VCPS - New School

210 12th Street NE, Valley City, ND 58072
Project #: 24-028
Addendum 02
03/24/2026

S106 – STRUCTURAL PLANS – AREA D – ALT #13

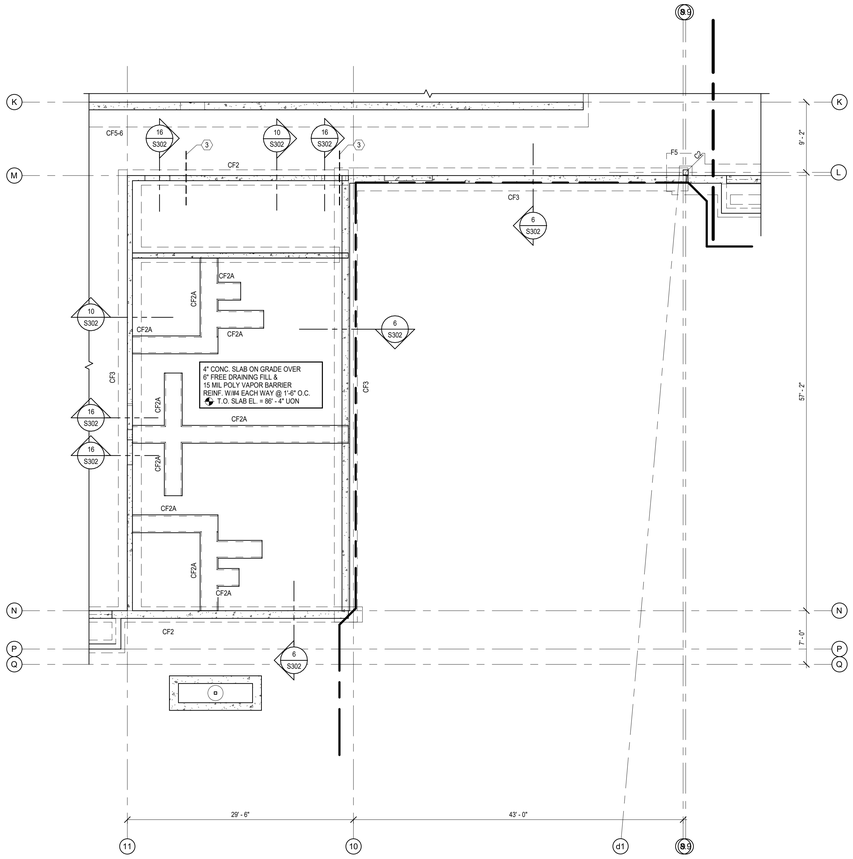
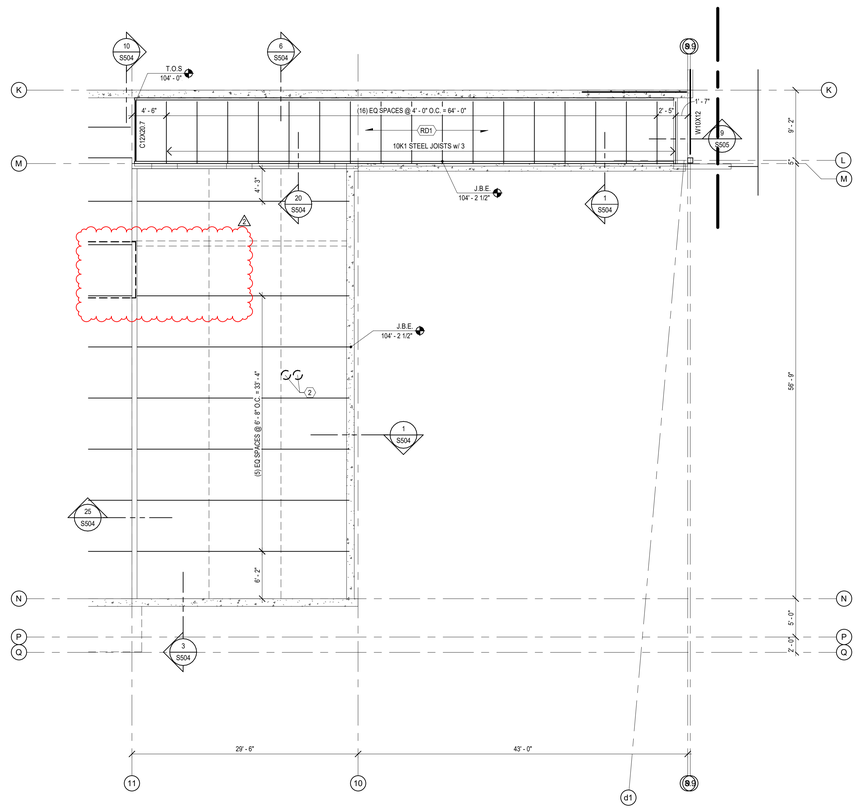
1. Remove linework for mechanical unit.

S111 – SNOW DRIFT LOADING PLAN

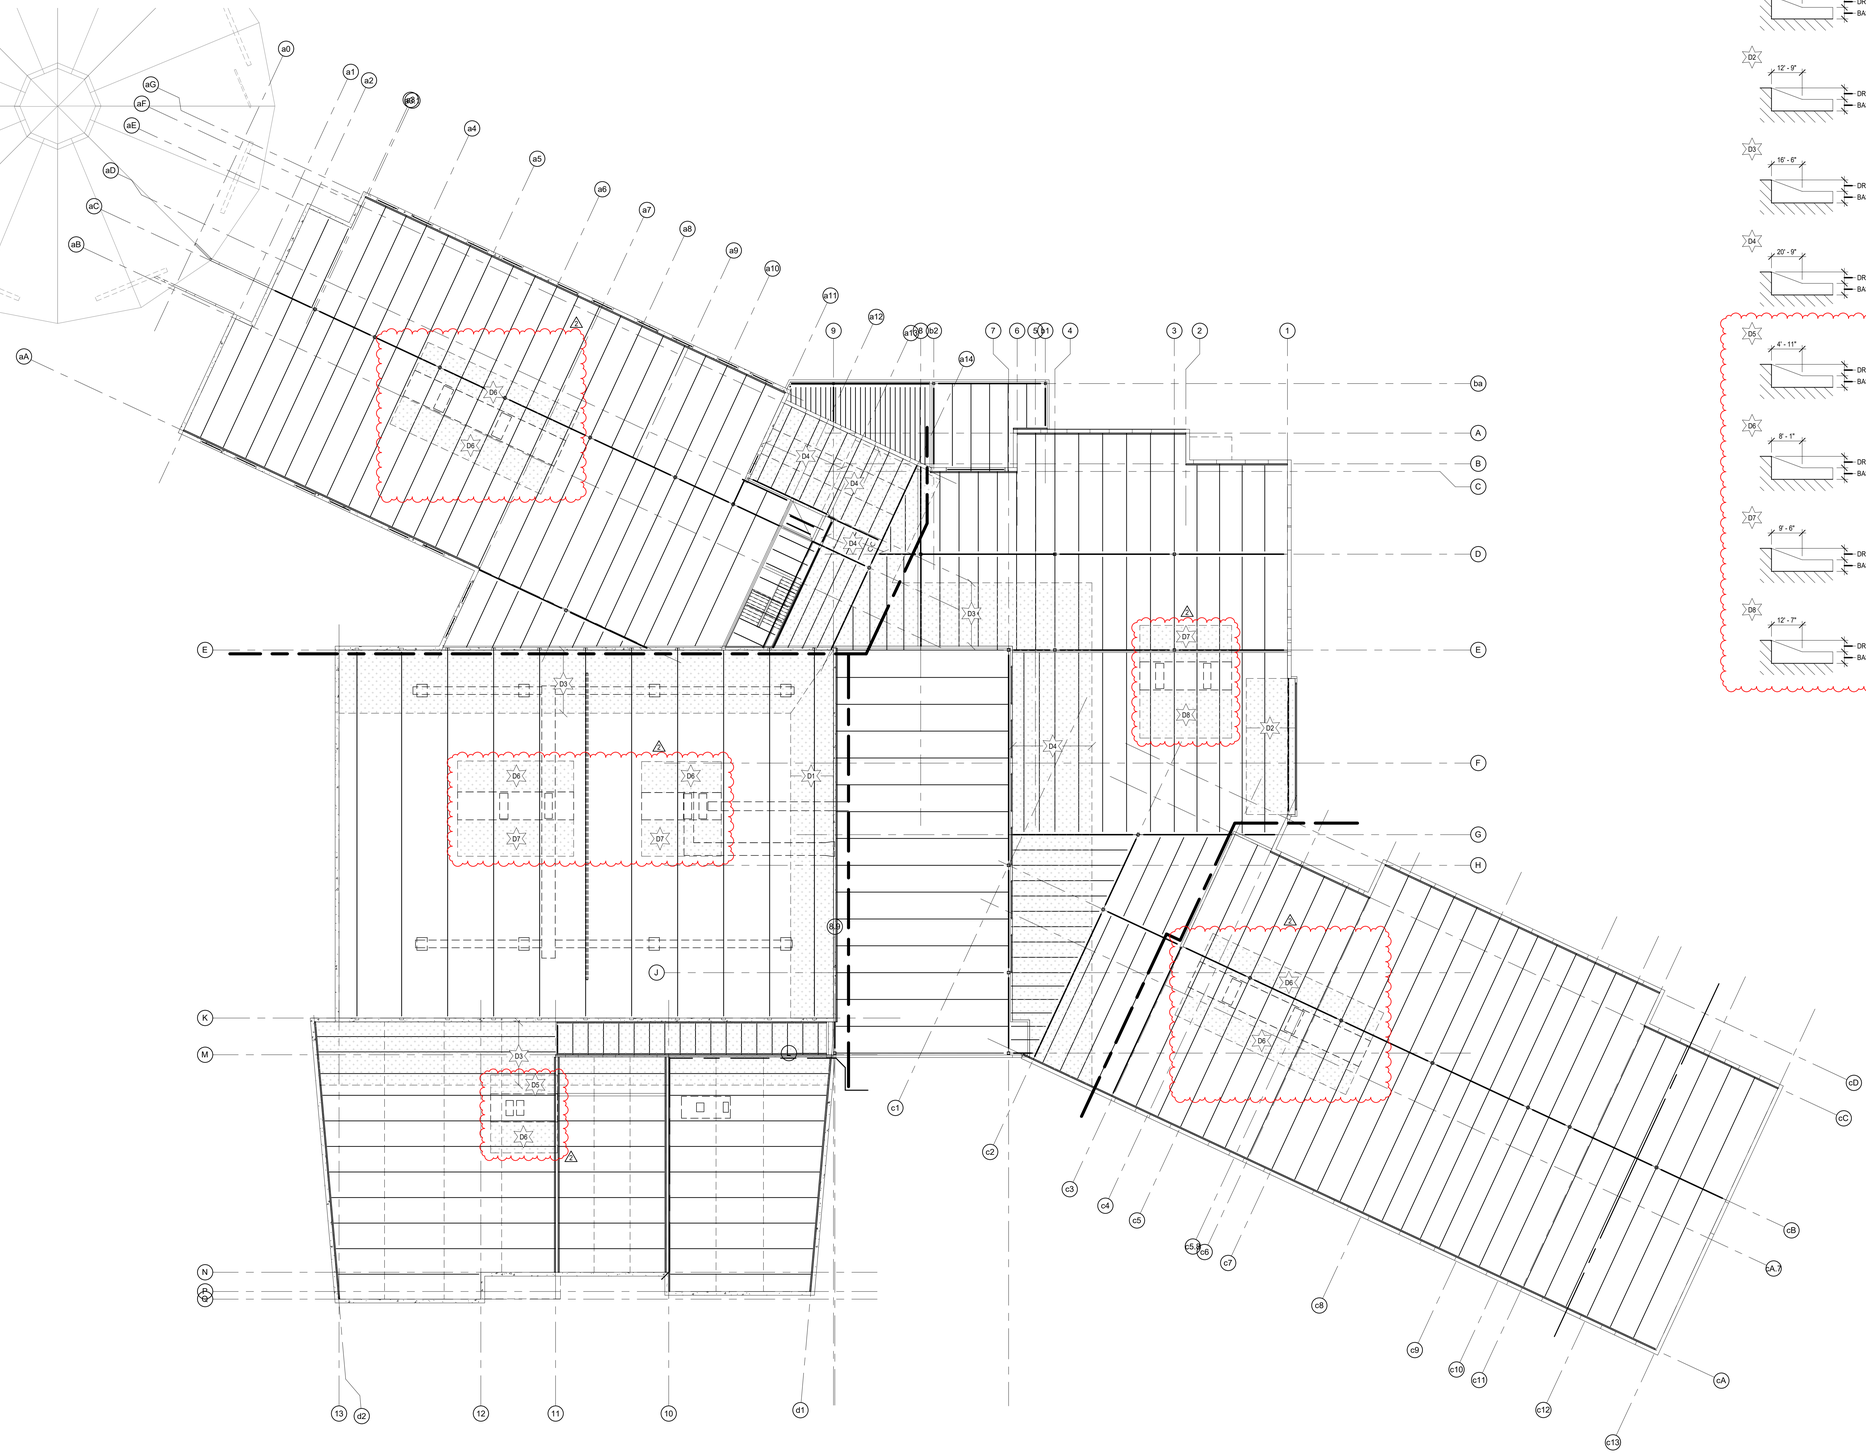
1. Add Drifts D5-D8 for snow drifts at mechanical units.

A105 – ROOF PLAN

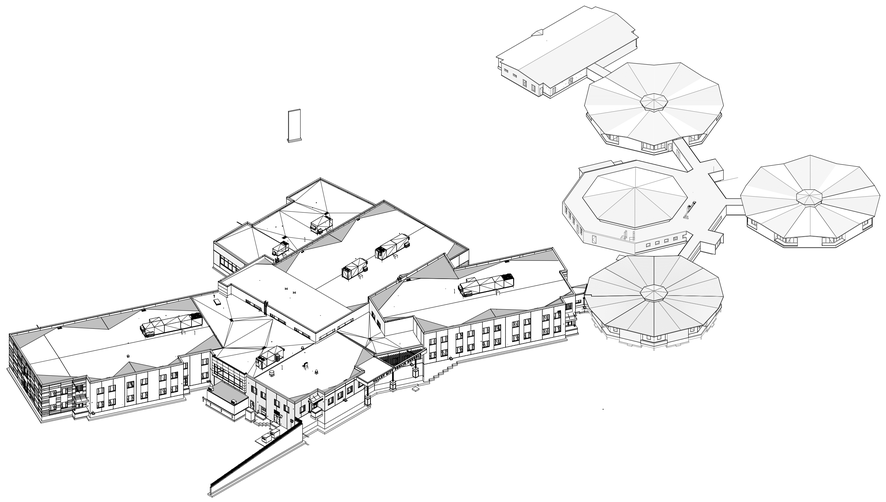
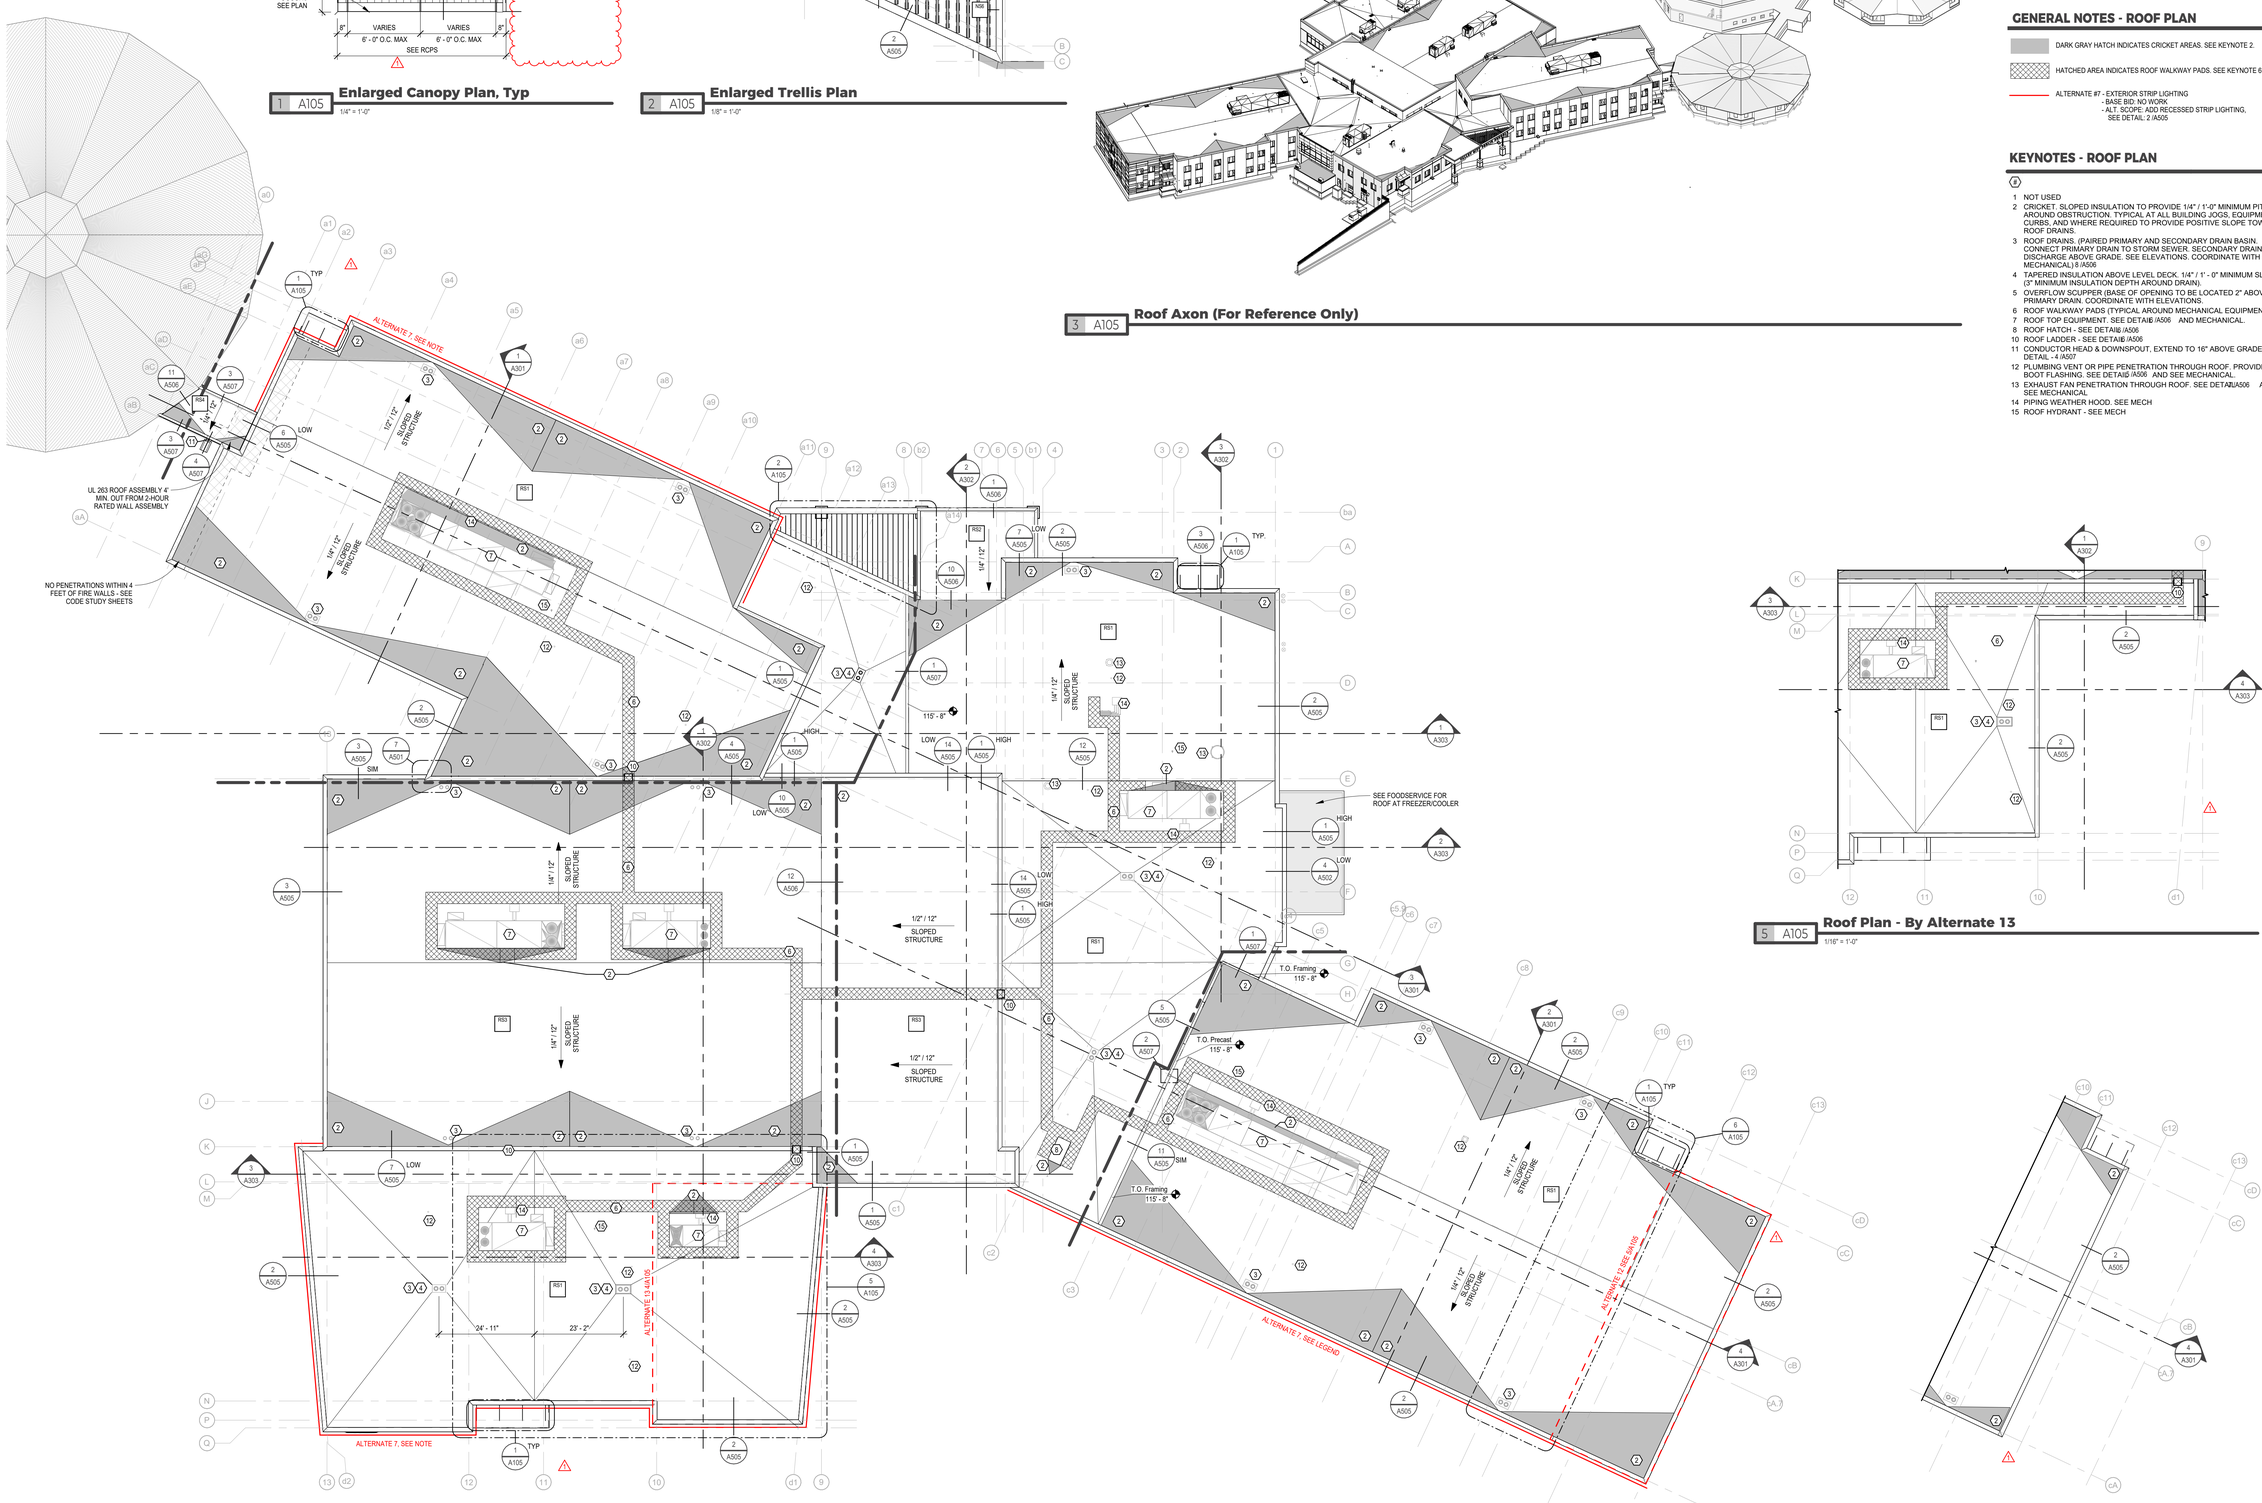
1. Adjusted annotations on enlarged canopy plan.

P203 – LARGE SCALE KITCHEN PLAN - PLUMBING

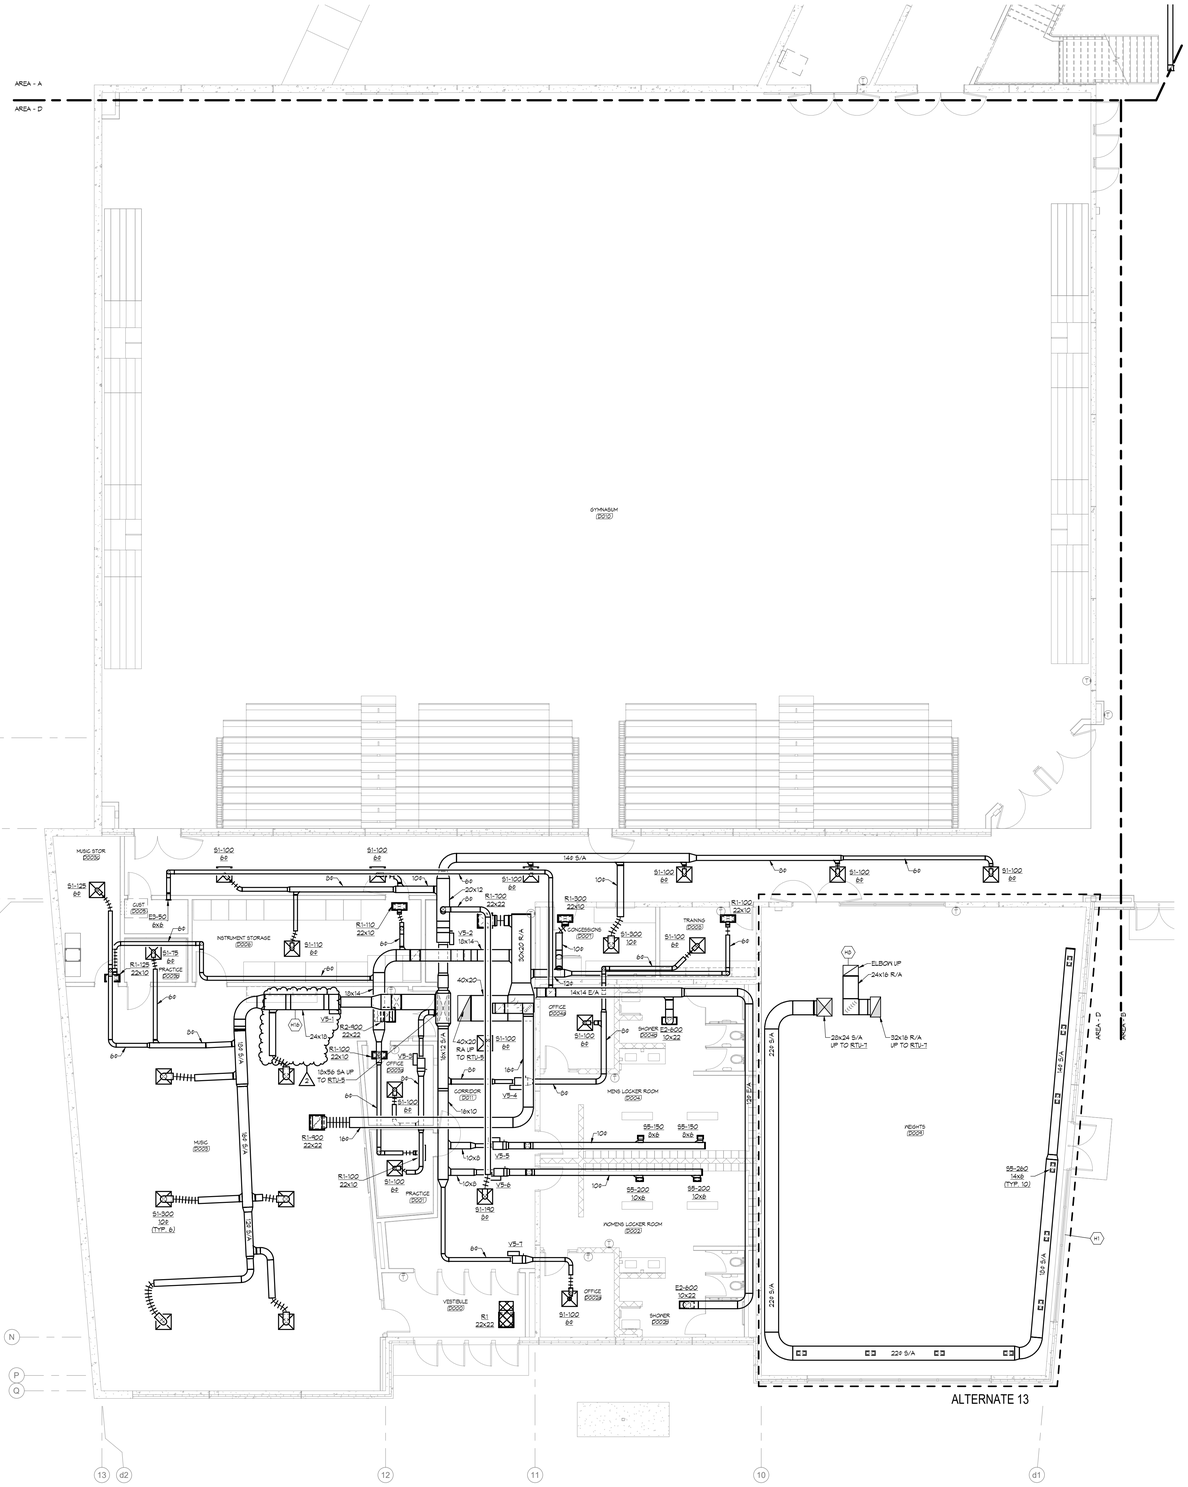
1. 3” waste line move plan West to adjust new location of FS
